TECHNICAL BULLETIN

407-14-111

MODEL AFFECTED: 407

SUBJECT: ENGINE FADEC SOFTWARE V5.400,
INTRODUCTION OF

Figure 1 – Markings Installation (Sheet 1 of 2)

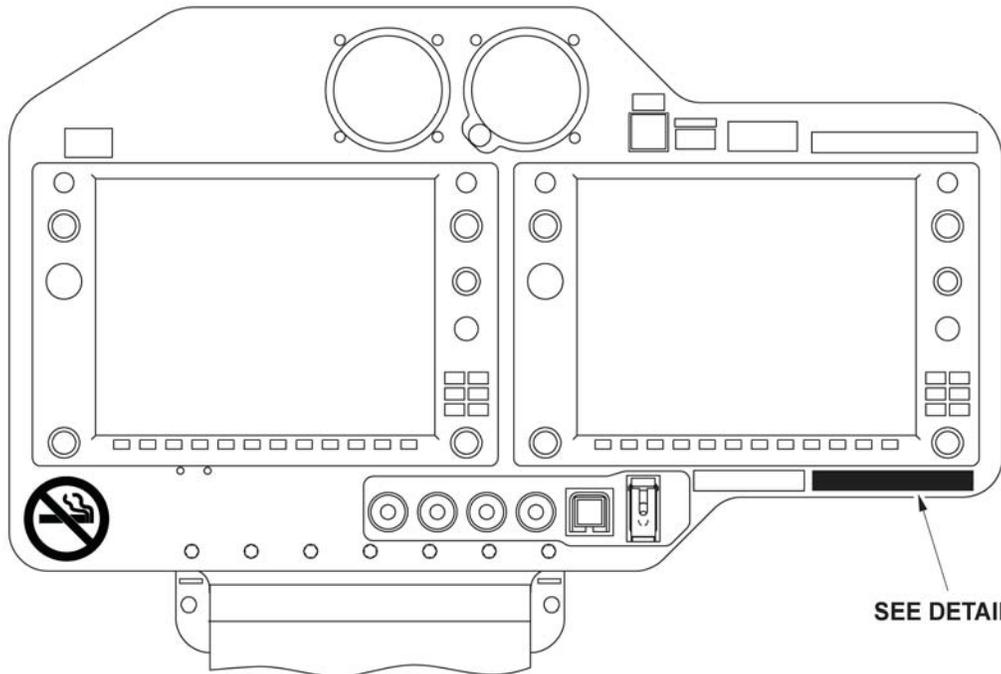
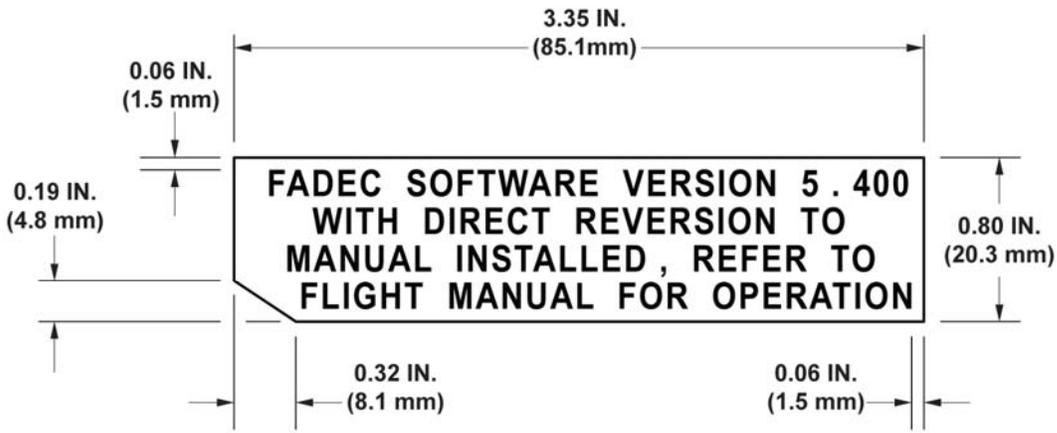
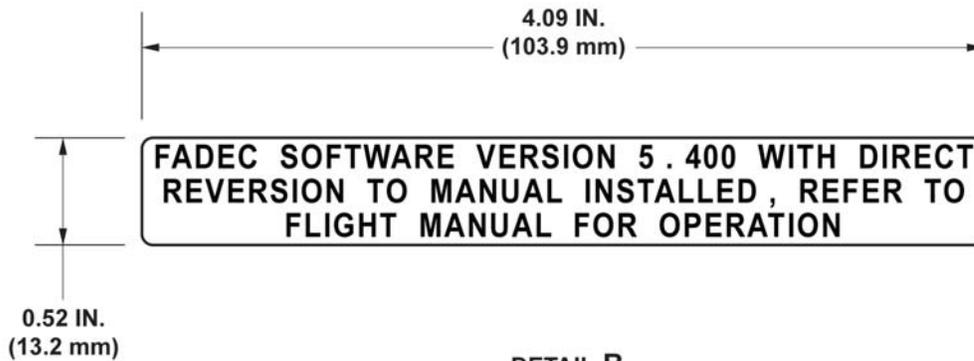
4. With a plastic scraper, remove and discard the existing FADEC software version decal located on the instrument panel. Wipe the surface clean with a clean damp cloth, moistened with aliphatic naphtha (C-305) (Figure 1).

5. Install applicable decal on the instrument panel in the location identified.
6. Seal the edges of the decal with edge sealer (C-349).
7. Insert temporary revisions into the appropriate Rotorcraft Flight Manual (RFM).

DETAIL A
 DECAL P/N 407-075-011-115
 (FOR S/N 53000 THROUGH 54299)

DETAIL B
 DECAL P/N 407-075-206-133
 (FOR 407GX S/N 54300 AND SUBSEQUENT)

Figure 1. ECU Identification Plate Replacement

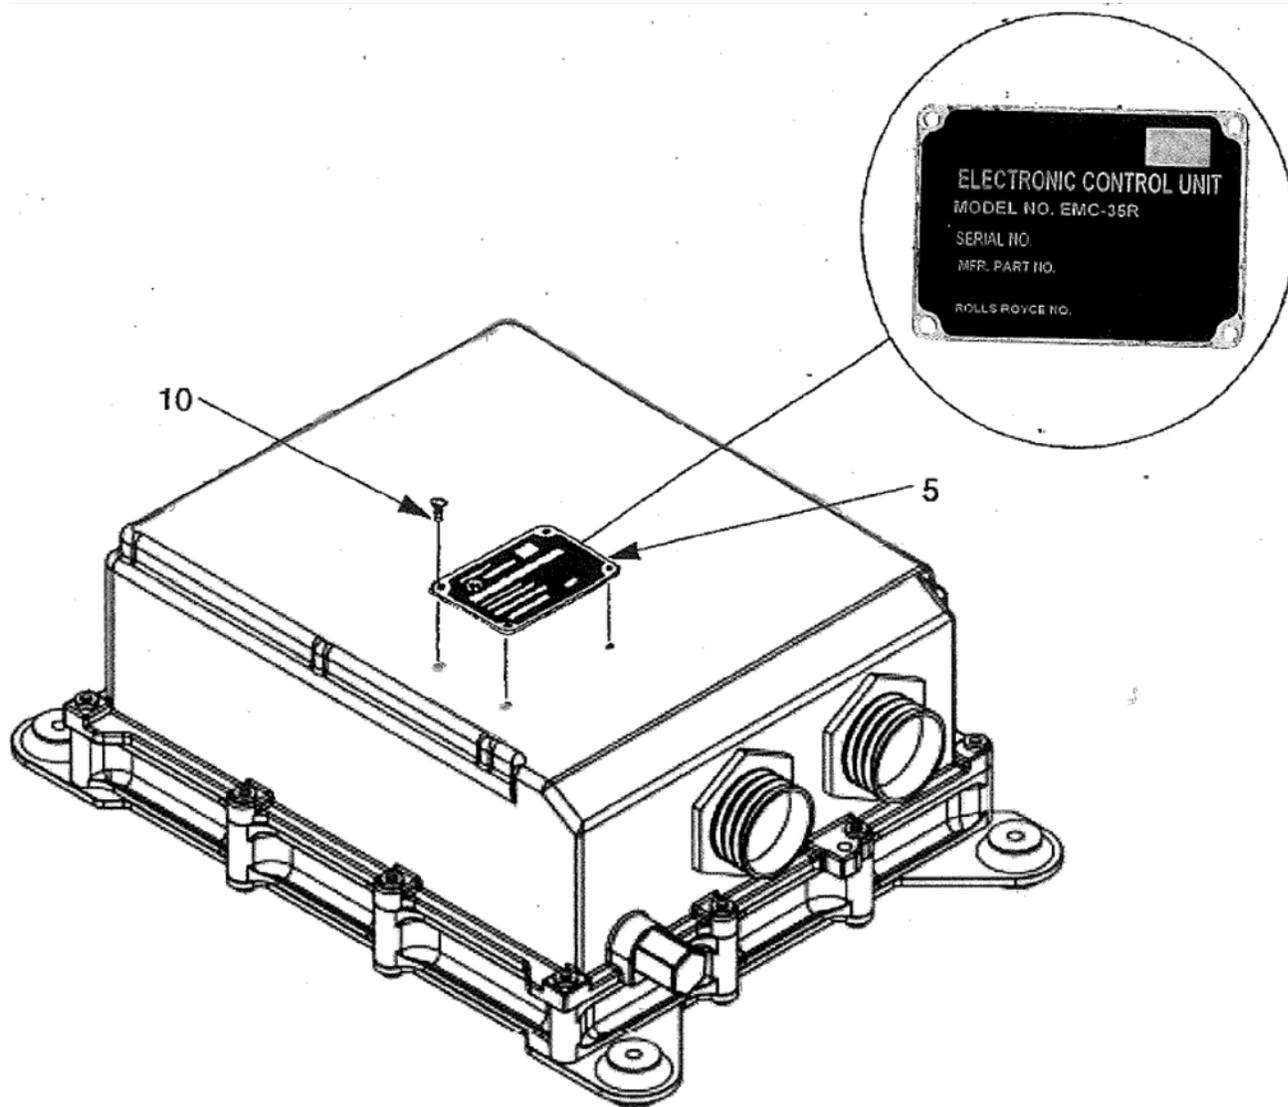
- (1) Replace the identification plate previously removed in step **2.G(1)** with a new identification plate (5, Figure 1) using four new screws (10, Figure 1) showing the appropriate Triumph part number (see Table below). Record compliance after new identification plate is installed on record data sheet, Appendix A, paragraph G.(1).
